Peninsula Township Fire Department

RE: 81 PUD Site review – further clarification on gates

**FIGURE D103.6
FIRE LANE SIGNS**

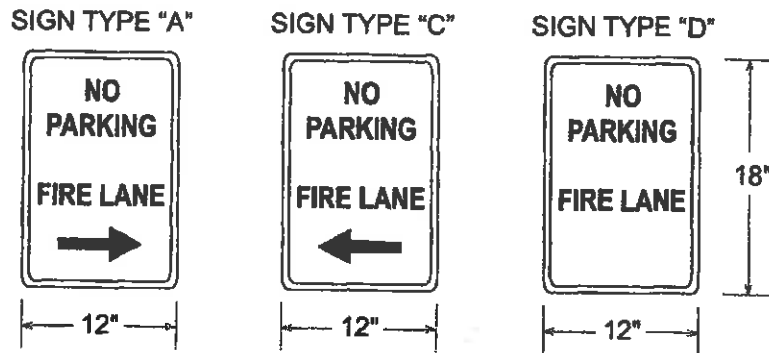
D103.6 Signs. Where required by the *fire code official*, fire apparatus access roads shall be marked with permanent NO PARKING-FIRE LANE signs complying with Figure D103.6. Signs shall have a minimum dimension of 12 inches (305 mm) wide by 18 inches (457 mm) high and have red letters on a white reflective background. Signs shall be posted on one or both sides of the fire apparatus road as required by Section D103.6.1 or D103.6.2.
